841227030B 841214
PDR ADCK 05000387
P PDR

ELECTRICAL POWER SYSTEMS

3/4.8.2 D.C. SOURCES

FIGURE TWO

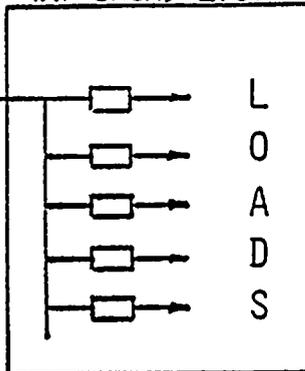
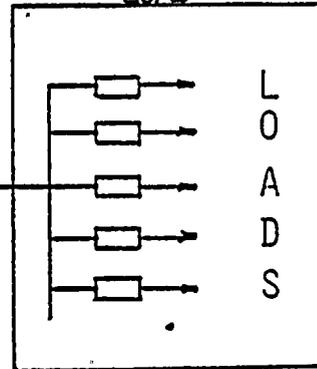
EXISTING CONFIGURATION

NEW CONFIGURATION

NEW MANUAL
TRANSFER
SWITCH

2. Transfer the Unit 1 and common loads aligned to the inoperable Unit 2 battery bank(s) to the corresponding Unit 1 battery bank(s).

Otherwise, declare the Unit 1 and common loads aligned to the inoperable Unit 2 battery bank(s) inoperable and take the ACTION required by the applicable Specification(s)
